Memo

To: JRPP
CC: Richard Davies,
From: Dianne James
Date: 4 April 2012
Subject: Sub-Acute Rehabilitation Unit, Goulburn Base Hospital, 130 Goldsmith St.
File: 174/1112/DA

BCA Assessment Report

Goulburn Rehabilitation Unit

A.2 RELOCATED BUILDING

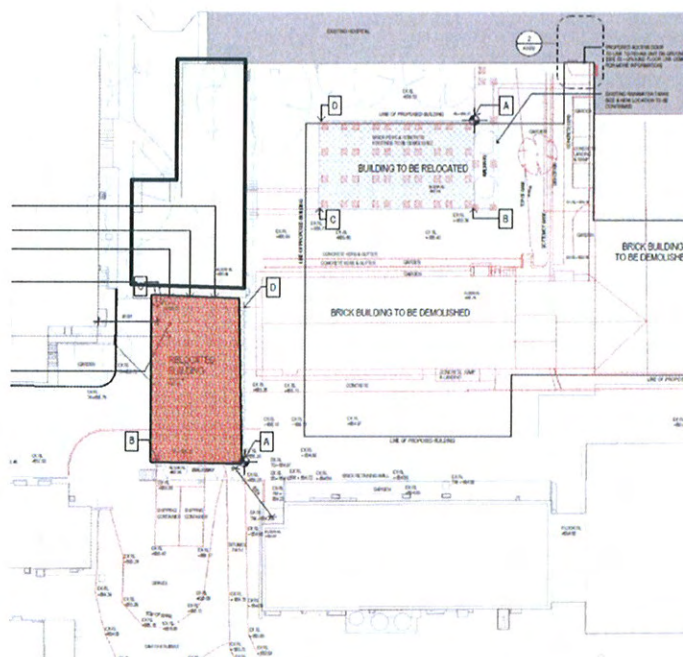
We note that whilst the demountable building will be positioned greater than 6m from the adjacent buildings to the east and west, the building to the north is located approximately 1m away which poses a risk of fire spread between the two building given that the demountable is of lightweight construction.

In this regard, we would recommend that this non compliance be addressed against the performance requirements of the BCA (prepared by a suitably qualified fire safety engineer), in which case the existing double brick building to the north will have the southern elevation entirely bricked up to achieve a minimum FRL of 120/120/120 to prevent the spread of fire between buildings.

4. Clause C2.5(a)(iv)(B) – Spandrels

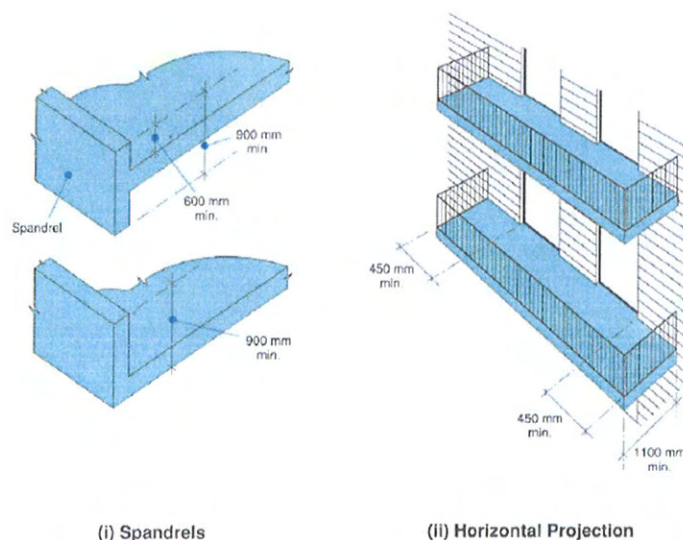
In this regard we note that spandrel separation has not been provided between the undercroft level and the ground floor plan. Additional details are to be provided in this regard.

5. Clause C2.7 – Separation by Fire Walls

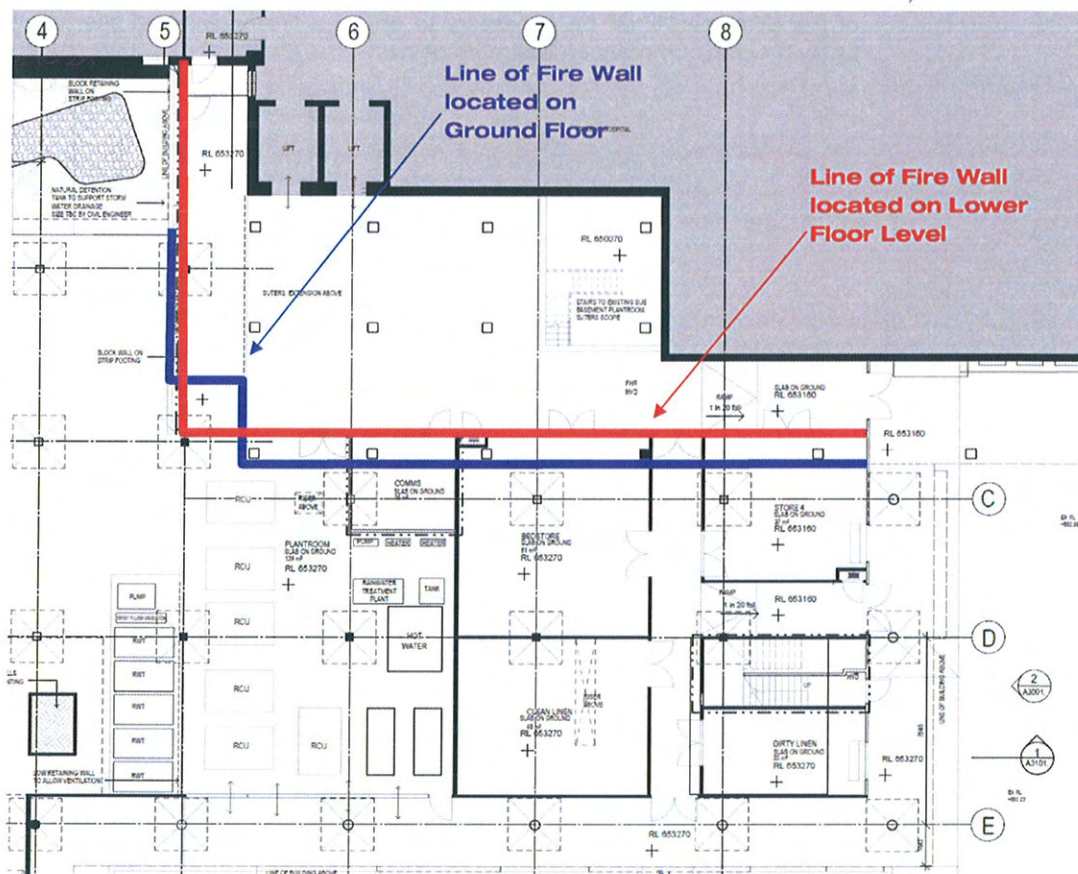
In this regard we note that the proposed fire wall located between the existing hospital building and Suters extension does not technically comply with the deemed to satisfy provisions of the BCA, in so far as the wall is not continuous between the lower ground floor and ground floor levels as indicated in the below diagram:

Whilst the above is a technical non compliance against the DtS provisions of the BCA due to not being continuous from the floor of the lowest level, this non compliance has been addressed against the performance requirements of the BCA by the Fire Safety Engineer..

7. Clause C3.3 -Separation of External Walls and Other Openings in Different Fire Compartments

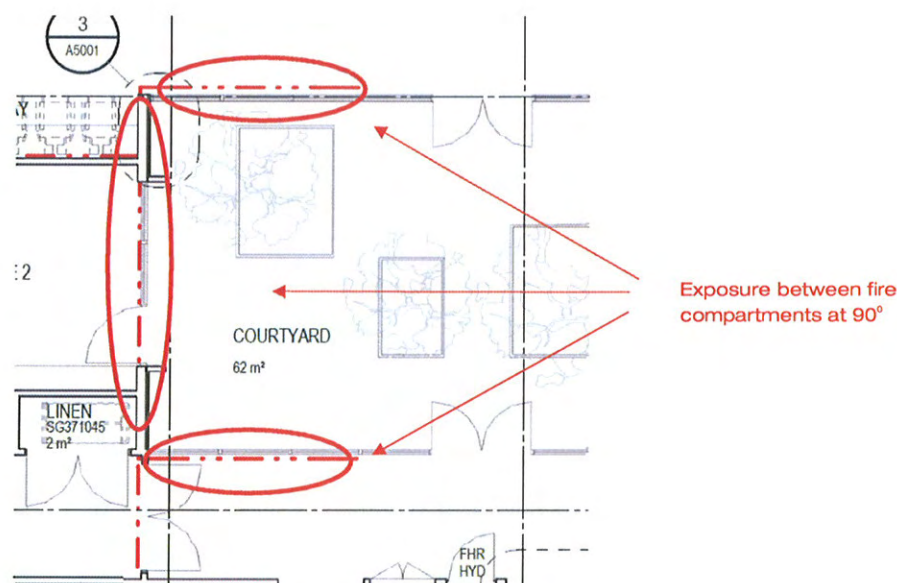
As a result of the proposed new works, we note that there are a number of openings within the external walls of the new RHU and the existing hospital building which are exposed to one another where located in separate fire compartments.

In this instance, should the openings of the new and existing buildings which are located within 4m of another fire compartment not be protected in accordance with Clause C3.4

of the BCA then it will be necessary to obtain a fire engineered alternative solution to justify the non compliances illustrated below:-

In this regard we note that the Fire Safety Engineering report addresses this matter by way of requiring the construction of fire rated walls or installation of drenchers. See Figures 2, 3 & 4 of fire engineering report for further clarification.
